UNITED STATES PATENT AND TRADEMARK OFFICE

Office Action Summary

10/628,848

ORTEGA ET AL. E

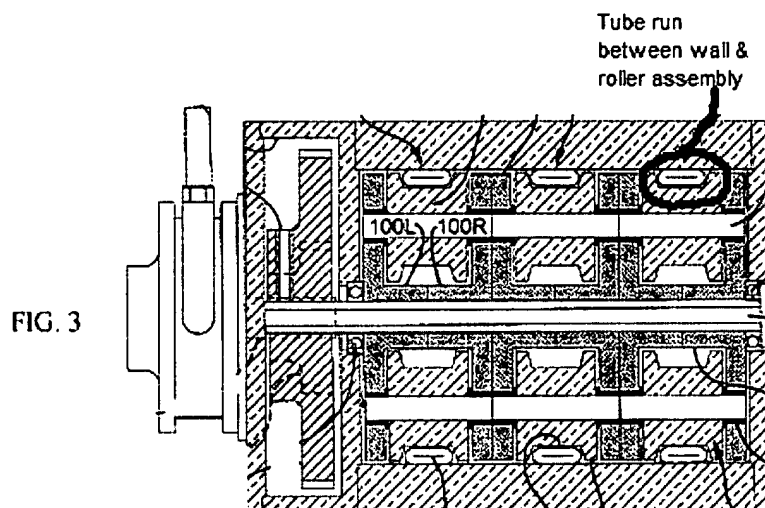
Claims 1-8, 10-18, & 20-21 are rejected under 35 U.S.C. 102(b) as being anticipated by Wells et al. (US Patent 6,041,709).

Wells et al. disclose a peristaltic pump for transporting a fluid within a flexible tube having a first end, a middle portion, and a second end, comprising: a roller assembly (Figure 2, item 110) positioned for rotation; a first door (Figure 2, item 82) positioned adjacent to said roller assembly and pivotable about a first direction; and a second door (Figure 2, item 84) positioned adjacent to said roller assembly and pivotable about a second direction; such that said first door and said second door may pivot open and said middle portion of said flexible tube may be positioned about said roller assembly; further comprising a base (Figure 3, items 86, 88, 90) such that said roller assembly may be positioned therein and such that said first door and said second door may be pivotably attached thereto; wherein said base comprises a tube inlet (Figure 2, item 118) and a tube outlet (Not labeled; However, clearly seen in Figure 2) positioned thereon; wherein said base comprises an indent (**See Note 1**) for said roller assembly to be positioned therein; wherein said base comprises a plurality of base hinges (Figure 2, item 92) for pivoting said first door and said second door; wherein said first door comprises a wall, said wall positioned adjacent to said roller assembly so as to define a tube run therein (Not labeled; However, clearly seen in Figure 3, **See Note 2**); wherein

said second door comprises a tube guide positioned thereon (Figure 2, item 112); further comprising locking means (Figure 2, item 94) positioned thereon for said first door and said second door; wherein said roller assembly comprises a plurality of rollers (Figure 2, item 106); wherein said roller assembly comprises a plurality of discs (Figure 3, items 100L & 100R) so as to mount said plurality of rollers thereon; wherein said plurality of discs comprises a plurality of roller mounting locations (Figure 3, items 108) such that the number of rollers may be modified; wherein said roller assembly comprises a plurality of replaceable rollers (**See Note 3**); further comprising a pump motor (Figure 3, items 128) in communication with said roller assembly; wherein said pump motor comprises a variable speed motor (column 8, line 49+); wherein said base, said first door, and/or said second door comprise acetal resin (column 7, line 43+)

- 1.) The bearings (Figure 3, item 96) of the roller assembly are received into base parts 88 & 90 via an indentation.
- 2.) Refer to the figure below.
